SUBJECT: DETERMINATION ON THE SUITABILITY OF DREDGED MATERIAL RETESTED UNDER RECENCY FOR THE U.S. COAST GUARD, PIER 36 SLIP DREDGING CHARACTERIZATION (2003-2-00333), EVALUATED UNDER SECTION 404 OF THE CLEAN WATER ACT (CWA) FOR OPEN-WATER DISPOSAL AT THE ELLIOTT BAY DISPOSAL SITE.

2. **Background.** The high ranked Slip 36 was previously sampled and tested during 1998, and the total volume subject to DMMP evaluation at that time was 33,130 cy. The testing outcomes were summarized in a DMMP suitability determination dated 2 November 1999, where 17,340 cy were deemed suitable and 15,790 cy unsuitable for unconfined-open-water disposal. Of the suitable material, three Dredged Material Management Units (DMMUs) comprising 11,580 cy were located within the surface (0-4 feet) and one DMMU (5,760 cy) was located in the subsurface sediments (>4 feet). The DMMP agencies in letter dated January 31, 2002 (Attachment 1), stipulated that only the three surface suitable DMMUs were subject to recency retesting, which is summarized below.

FIGURE 2

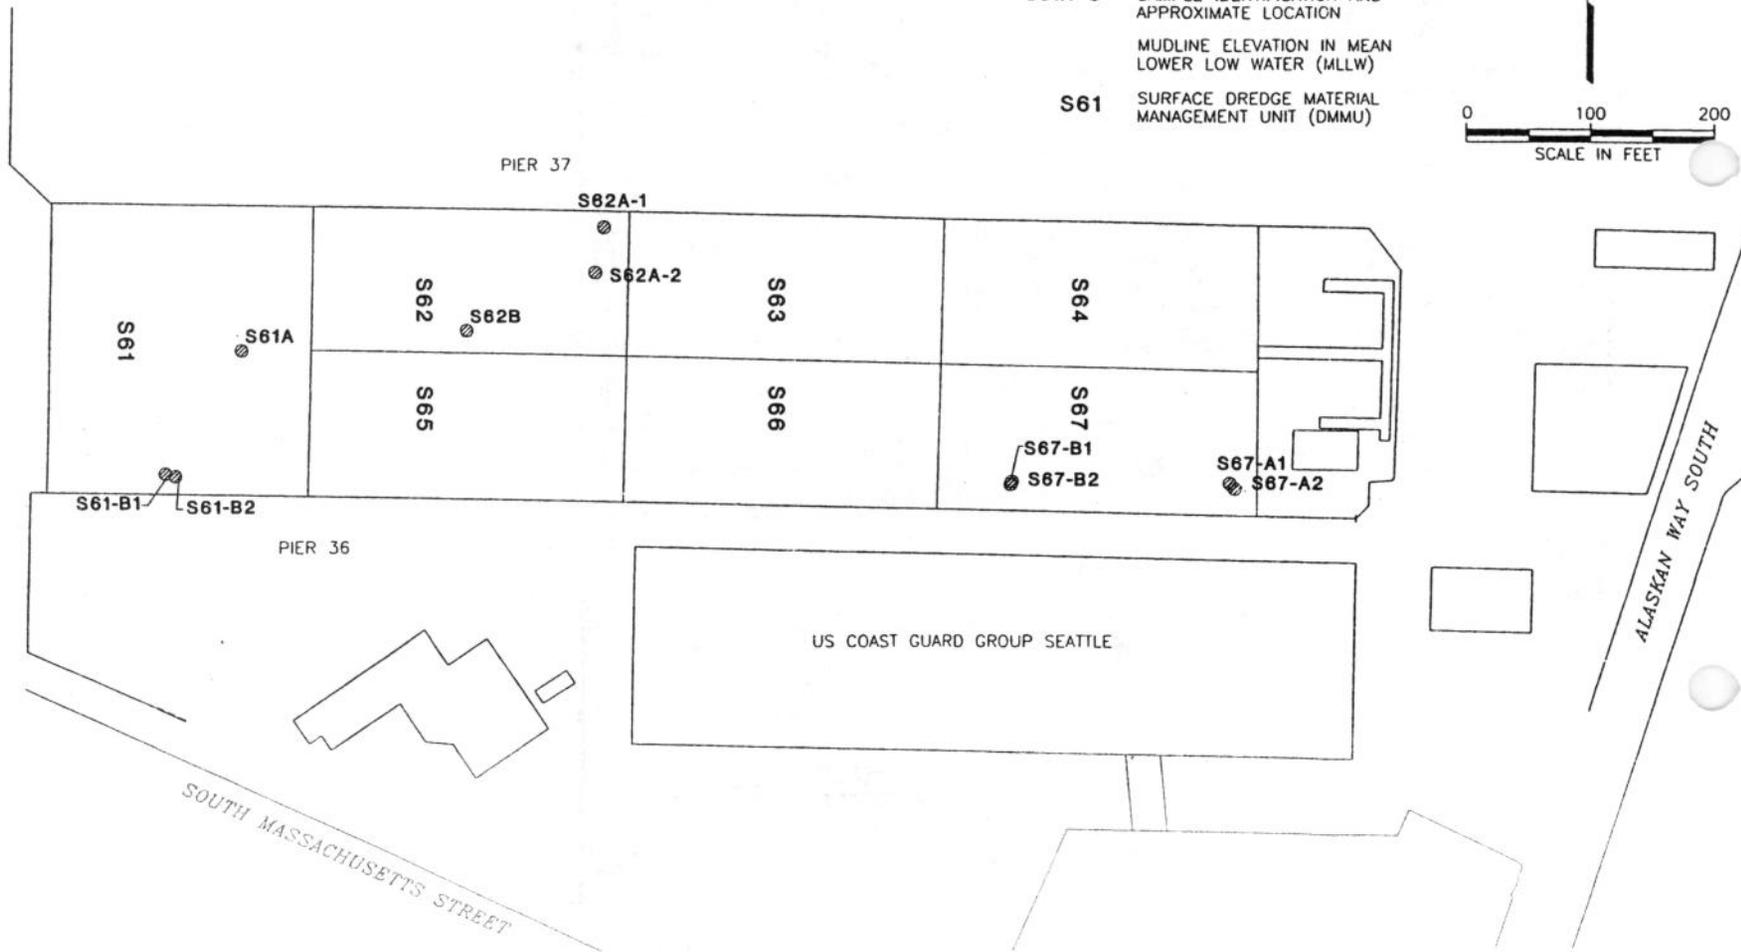
5. Sampling was initiated on November 14, 2002, and 10 sediment cores were collected by vibracorer within the three DMMUs (see Figures 1 for vicinity and 2 for sample core locations for DMMU's S61C, S62C, and S67C). Three samples were composited for DMMUs S61C and S62C, whereas DMMU S67C was comprised of 4 core stations. No Z-samples were collected and archived.
